SUBJECT: Rudder Cable Assemblies

REVISION: Initial Release (IR)

**AIRCRAFT MODEL: Pitts Model S-2, S-2E, and S-2A Aircraft
(CERTIFIED IN ANY AIRWORTHINESS CATEGORY)**

The view above is from the S-2A part list document 70183-001. The view shows the installation of the rudder cables part number 2-3150-2 (item 11) turnbuckles (item 12), forks (item 13) rudder cable fairleads (items 18 and 19).

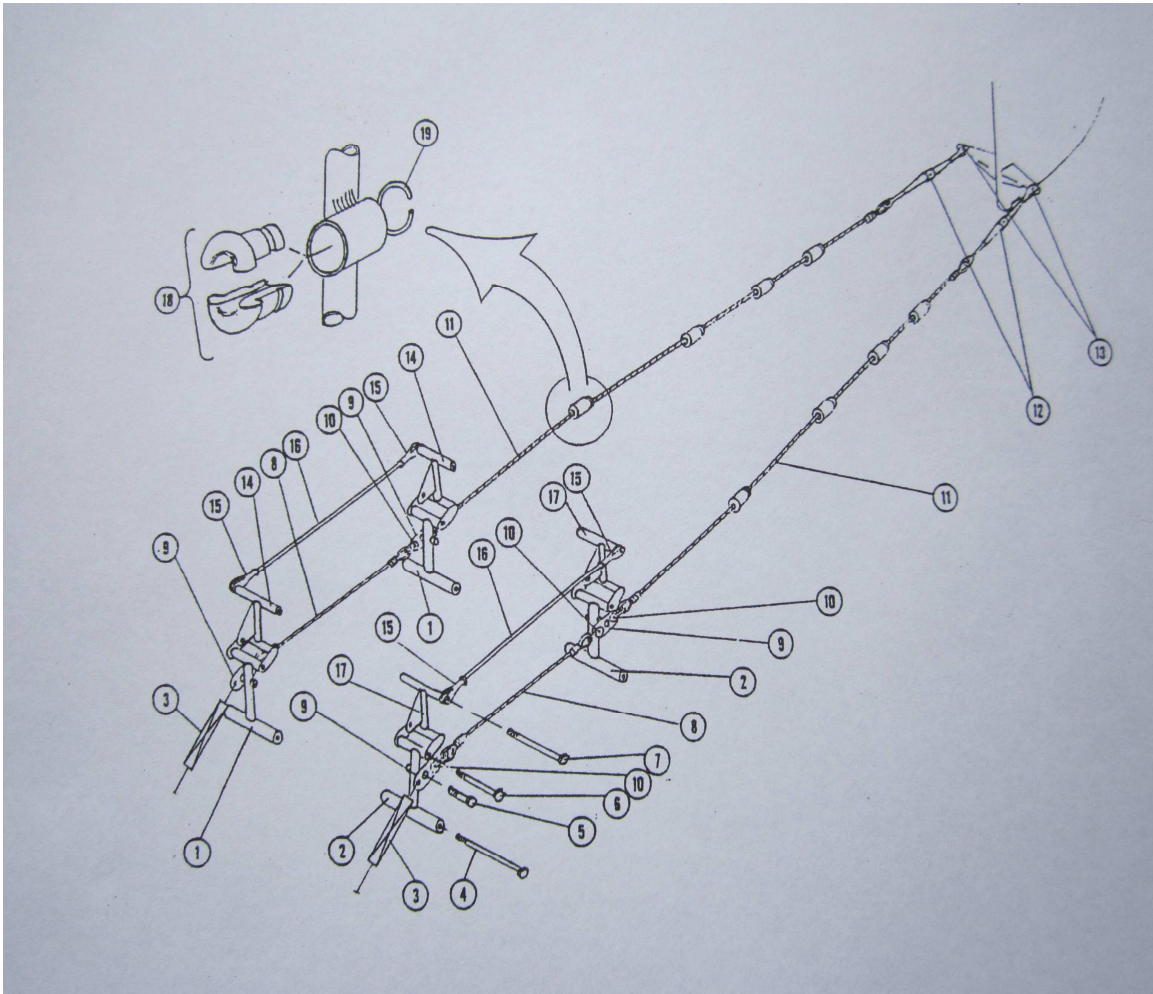
Using the view on page 3 of this service bulletin as reference, remove the 2-3150-2 rudder cables (item 11) including the AN155-16S turnbuckles (item 12) and AN161-16LS forks (item 13) at the rudder attach point by removing the AN380-2-2 cotter pins, AN310-3 nuts, AN960-10 washers, and AN3-6 bolts.

Remove the rudder cables from the rear rudder pedals by removing the AN380-2-2 cotter pins, AN310-3 nuts, AN960-10 washers and AN3-5 bolts. Next remove the fairleads 4 places on each cable in the fuselage. The fairleads can be accessed through the inspection holes in the fuselage. Be careful pulling the cable through the fuselage fabric as the fabric could be damaged.

Install the new part number 2-3150-7, which does not use the removed turnbuckles or forks, in the reverse order as above. Replace any worn or damaged hardware with new hardware. Verify all hardware at the rudder and rudder pedals are installed and all cotter pins are installed correctly. Special attention should be given to rudder cable attach point at the rudder, verifying that the rudder cable aligns straight to the rudder, the rudder cable moves freely and that there are no modifications, repairs or damage to the attach points at either end of the cable which might interfere with proper operation of the rudder control system. Verify proper operation and rudder travel in accordance with Owner's and Maintenance Manual document number 70196-001.
